Paragraph 6.2.1., in working document ECE/TRANS/WP.29/GRSP/2010/31, replace the image (including the text boxes):

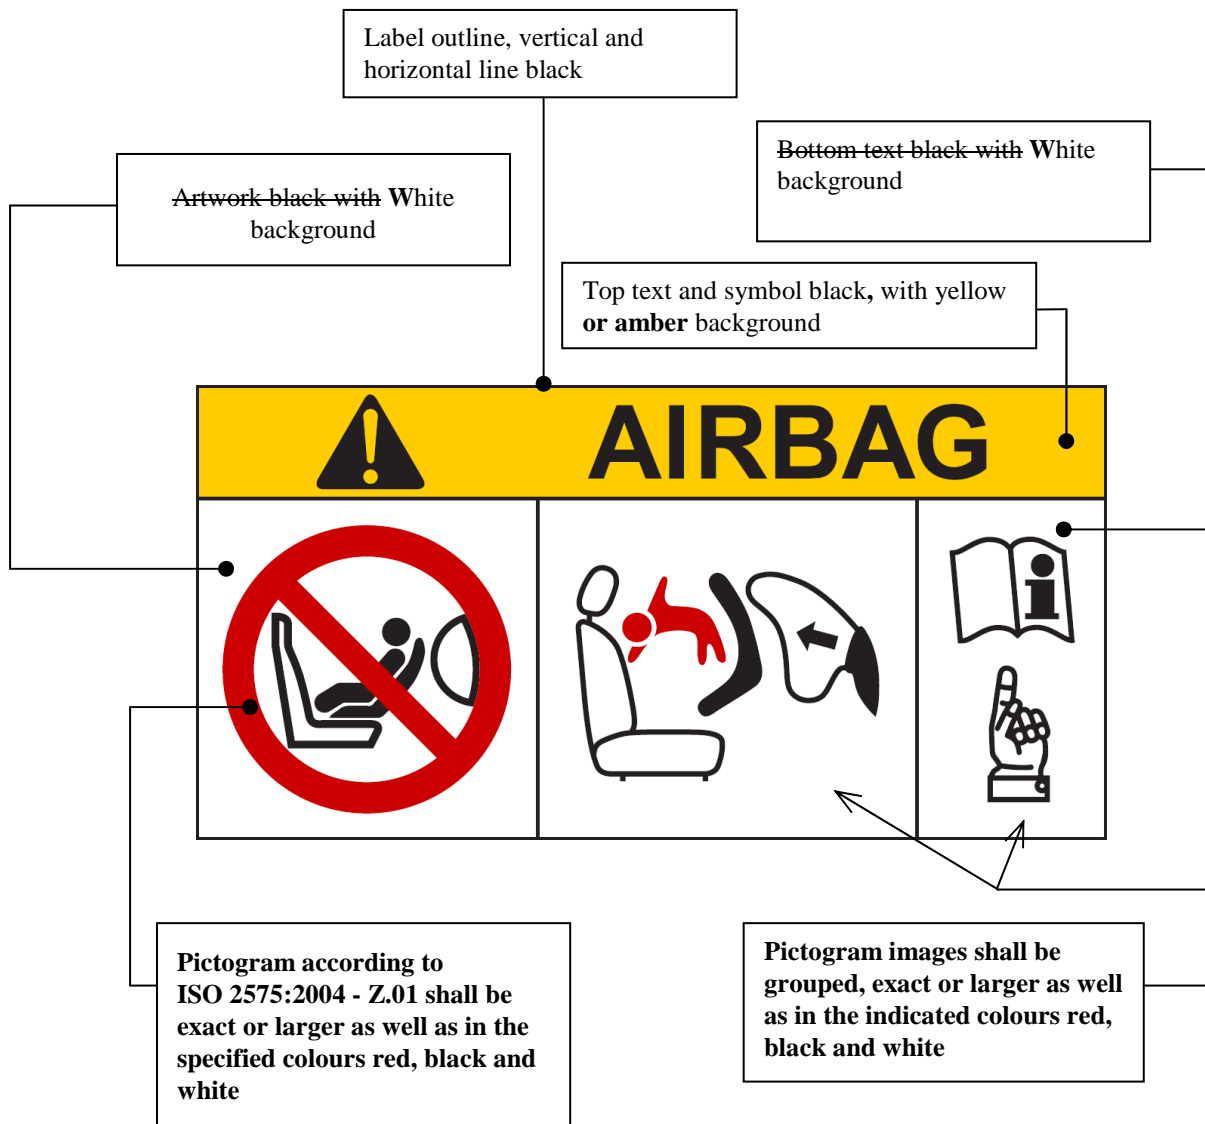
1. Preliminary results of the study carried out by TRL (U.K.) on behalf of the European Commission, indicate that the overall comprehension rating of the original label (“Version A”, with translated text) is nearly equal (i.e. no statistically significant difference) to the rating of a newly proposed label (“Version C”, without relevant text) which has been developed in cooperation with Consumers International, ANEC, OICA, JAMA, CLEPA, Dorel and the European Commission. The originally proposed label (“Version B”, without relevant text) rates lower than the other versions.

2. Almost a third of the respondents in the research, which viewed the proposed label (“Version C”) understood that in addition to the general message of the label, relevant information could be found in the instruction manual or booklet. Although this number may not be overwhelming, the original label scores less than just 1% on any link to relevant instructions.

3. Taking into account the above findings, the proposed label (“Version C”) as included in this informal document, should be taken into consideration instead of the label which is currently included in the working document.
